ARCHITECTURAL REVIEW BOARD MEETING

Thursday, February 29, 2024 at 7:00 PM

2. COA 23-91: 206 Culpeper Street

ARCHITECTURAL REVIEW BOARD CERTIFICATE OF APPROPRIATENESS 23-91

Revised Plans:

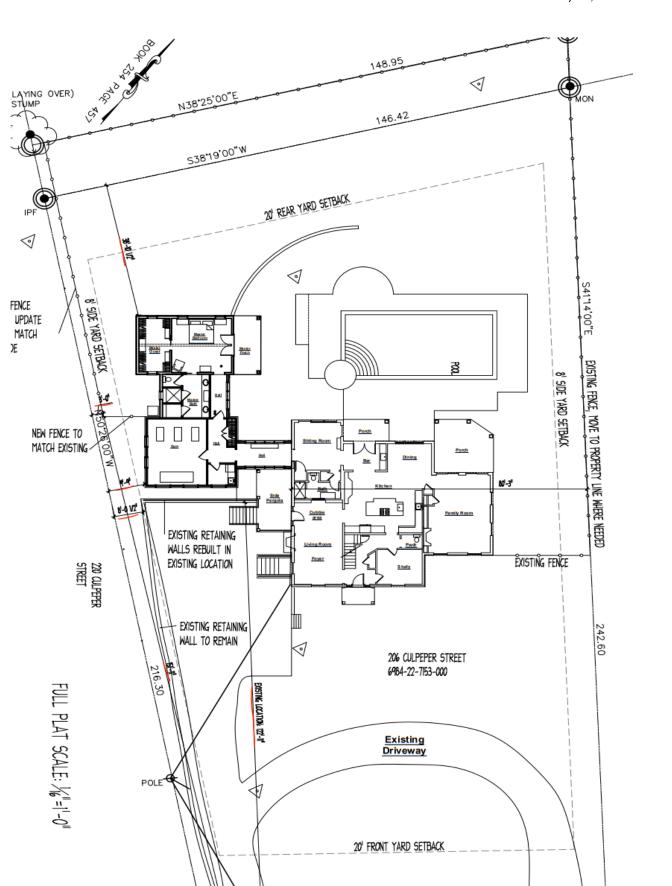
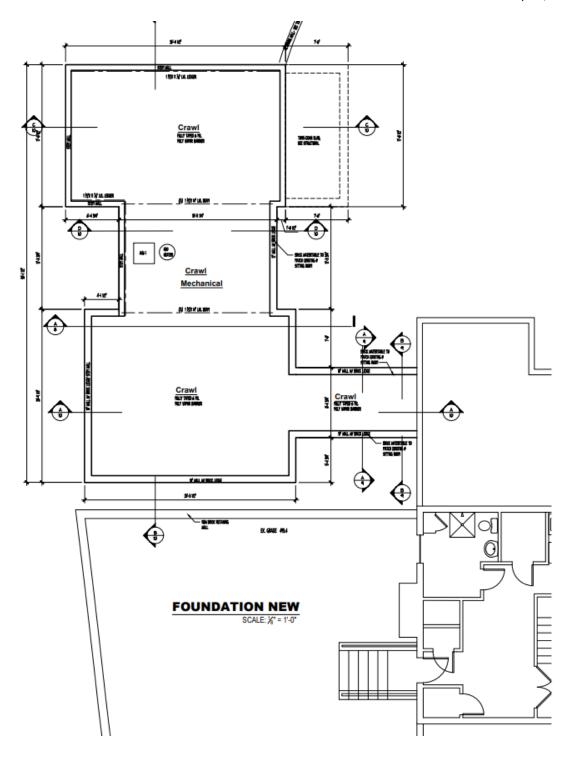
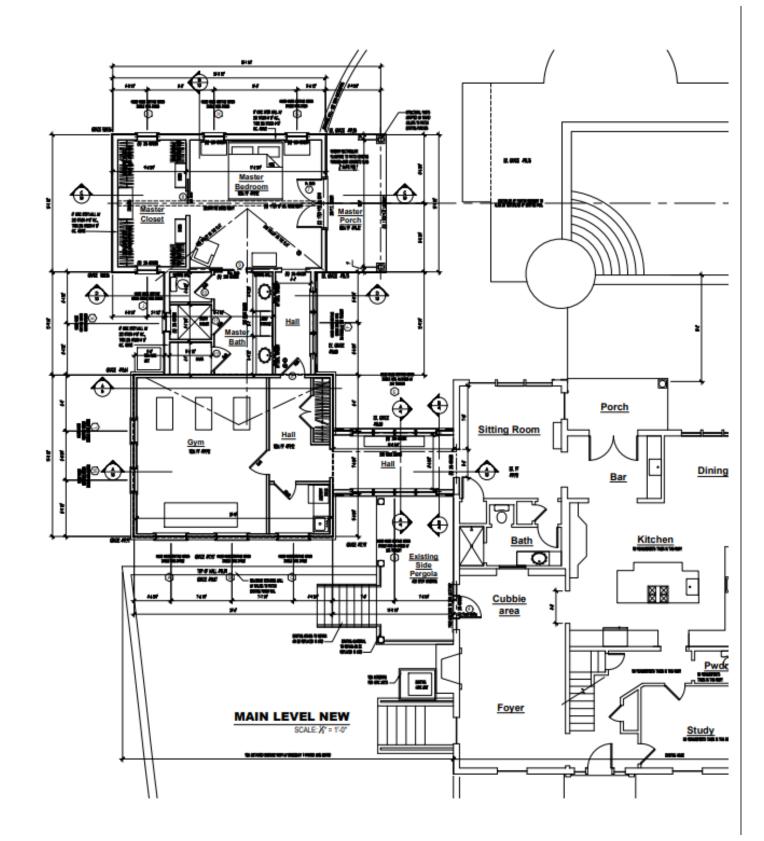
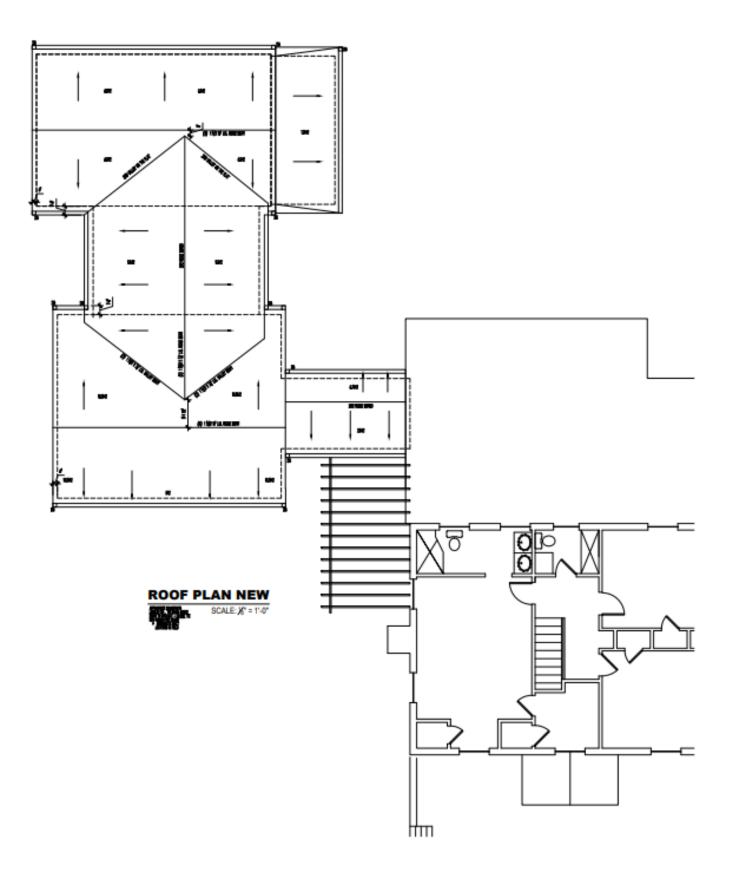
The applicant is proposing the following modifications to previously conditionally approved COA 23-45 at the ca. 1950s main house at 206 Culpeper Street:

- Remove Garage/basement level of addition.
- Exercise room and Laundry area reworked with gable roof and no dormer and white washed brick façade.
- Breezeway on rear elevation reworked.
 - The breezeway that was proposed in the original application has been reworked and a portion has been removed.
 - None of the existing structure is being altered.
 - The new breezeway materials will be wood windows, wood trim to appear as columns and whitewashed brick water table to match the existing adjacent sitting room exterior.
- The existing retaining wall will be replaced with a new wall faced with brick.
 - The retaining wall at the front of the addition will be replaced with a new wall (same height around 4.6 ft)
 - The green scalloped railing will be replaced with a 3 ft railing to match existing white railing on the porch.
- Fence/railing on wall to match existing rail at side porch.

I move to approve the application for **Certificate of Appropriateness 23-91** for the request to modify previously approved COA 23-45 to include the following modifications: 1) to remove the garage/basement level of the previously approved addition to the main house; 2) to install a gable roof with no dormer for the previously approved addition; 3) removing a portion of the previously approved breezeway; 4) to replace wall face of existing retaining wall with brick; and 4) to install new fencing on the southwest side of the property to match existing scalloped fencing at side porch, all as described and depicted within the application, at **206 Culpeper Street** with the following conditions:

CURRENT PLAN (patio size cut back):

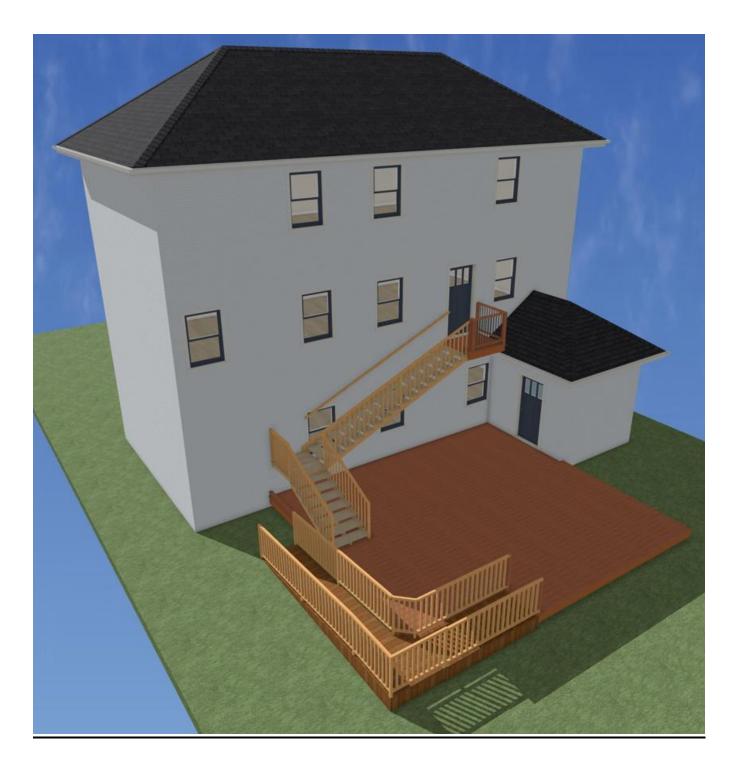
Revised patio dimensions:

- The modified footprint will be a 575 Sqft deck in sealed natural wood with an ADA ramp and stairs (existing) to the 2nd floor.
- Previously it was a 55' long by 13' and 23' wide wood patio; 24" maximum height

4) The patio shall be appropriately screened with native shrubbery/plantings to obscure the patio framing and to provide additional visual interest to the landscaping.
